ASW 19, L-308
ASW 20, L-314
Maintenance Instruction
H

Type: Instructions regarding maintenance and adjustment.

Subject: Adjusting the towhook after an unintentional release.

Affected gliders: All ASW 19, ASW 19 B, ASW 20 and ASW 20 L.

Supplement to 2.c):

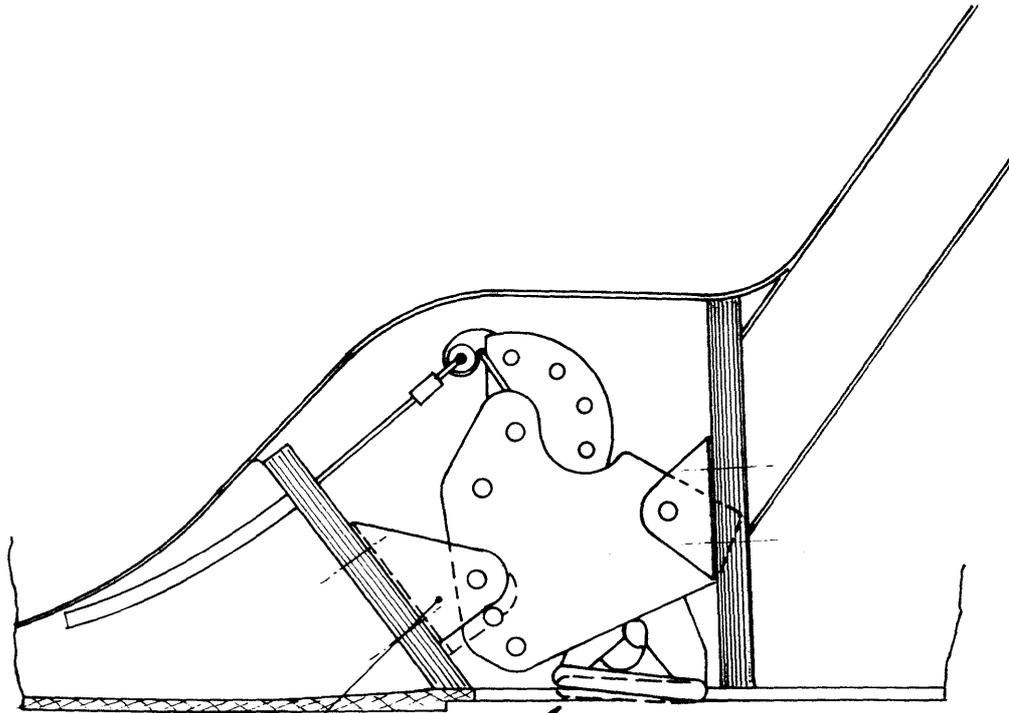
- c) After a belly landing and/or if water has been allowed to stand in the cockpit for a long period, the glued joint between the rear towhook bulkhead and the fuselage shell may fail. This weakens the towhook installation to the point where the towhook may twist under a severe load (such as occurs during cable snatches); this movement may be enough to cause a stiff and/or too critically adjusted towhook cable to open the latch of the towhook (see pages 3 and 5 for more information). In this case the glued joint between towhook and bulkhead must be repaired. Clean up the glueing surface and fill the slot (e.g. made with a piercing saw blade) with a filler paste consisting of:

A successful reinforcement to the forward towhook bulkhead of the C.G. towhook has proved to be two wedge-shaped plywood blocks (see sketch on Page 5). Two layers of glass cloth 92140 are laid over the joint surfaces of the blocks, with random fiber orientation, and resined together. Do not forget to preserve the water drainage holes.

New, modified towhook fitting.

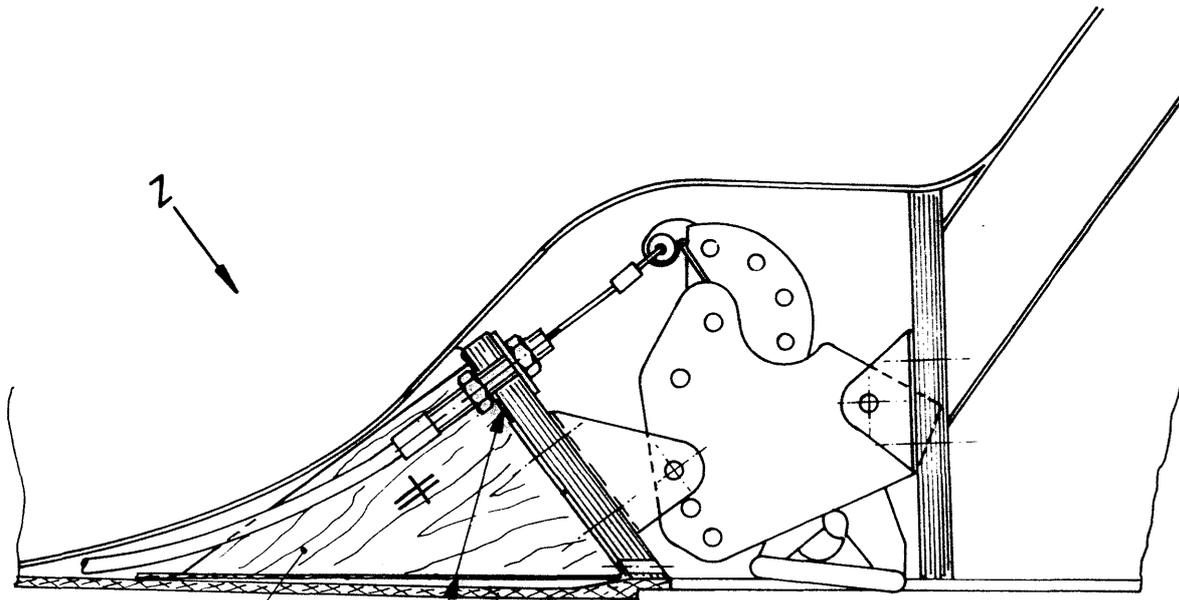
- b) If the measures described in a) do not help, the forward towhook fitting can be modified. To do this it is usually necessary to make up a new fitting which is designed to suit the particular installation. In this case you must contact the manufacturer so that a new fitting can be manufactured.
Good results have been achieved with the new ring pair, if the towhook is sunk into the forward fitting far enough for the automatic towhook ring to run almost parallel to the outside contour (see accompanying sketch).

Automatic ring almost parallel to outside contour.
